Our Ref: P-16188

RE: DA 245/2017 | 552 TO 568 OXFORD STREET, BONDI JUNCTION

As Council would be aware, the Sydney Eastern City Planning Panel deferred determination of the abovementioned Development Application (DA) on 30 November 2017, until four (4) items were addressed. These items are addressed below.

Figure 2: Extract of first floor converted to commercial and related uses (Source: UP Architects/Kann Finch)

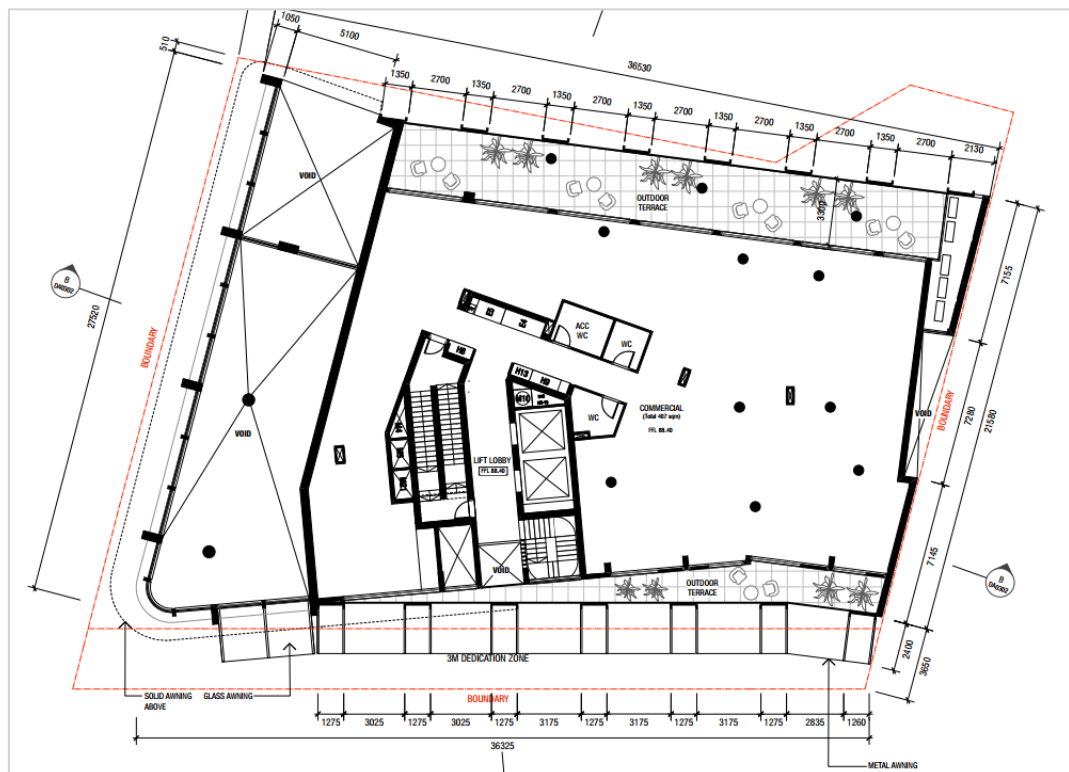
Provide commercial use on the first floor

Whilst this is not the proponent's preferred use of the first floor, the plans are nevertheless amended to provide a significant commercial offering on the revised first floor plan (refer to drawing number 0107 or extract below).

Figure 3: Comparison of original DA GFA (left) and proposed GFA (right)
(Source: UP Architects/Kann Finch)

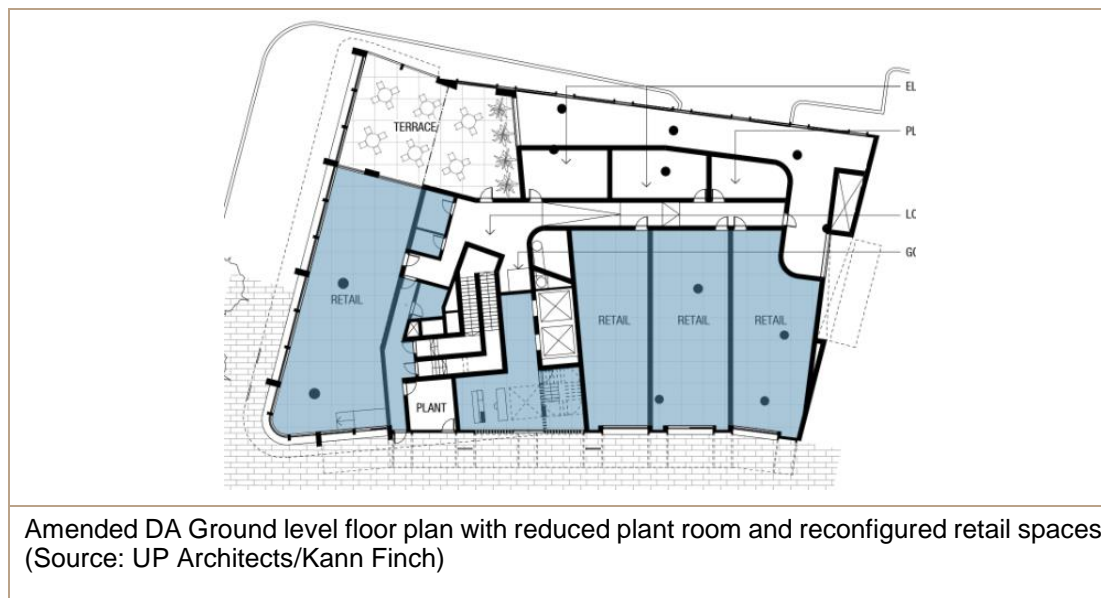
Comply with the maximum FSR of 7:1

The proposal has been amended to now include a total gross floor area (GFA) of 7,889m². With a site area of 1,127m², this equates to a compliant FSR of 7:1.

The original Development Application (DA) submission included a GFA of 8,010m². This has been reduced by reducing the GFA of Level LG, Level G, Level 1 and Level 6. The following tables summarise GFA for each level as provided in the original DA submission, and the current submission.

Figure 4: Ground level plant room comparison between the proposal and 'The Vue' on the immediately adjoining eastern allotment (Source: UP Architects/Kann Finch)

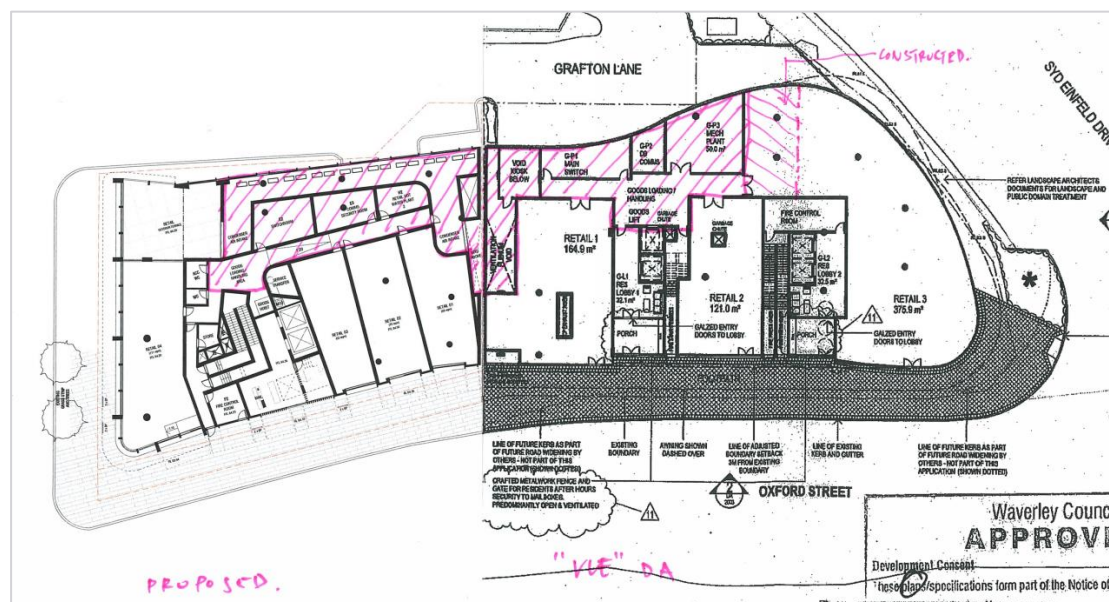
Relocate plant room from the ground floor

The plans have been amended such that as much plant and/or other related mechanical equipment has been removed from the ground floor. Specifically, the following items have been relocated from the ground floor:

- 2 x 80,000L water tanks - relocated to Basement Level 4;
- Stormwater detention/rainwater tanks - relocated to Lower Ground level.

It is reasonable to expect some plant room to remain above ground. In the case of the amended plans, condensor units, electrical room and other plant facilities remain on the Ground level. The condensor units, in particular, must remain above ground for air intake and exhaust purposes. Some plant rooms are proposed on the Lower Ground level.

It is also worth noting that, as demonstrated in the comparison diagrams on the following page, the extent of ground floor plant room in the amended proposal, is similar to that provided on the ground floor for the recently completed 'The Vue' development on the adjoining property.
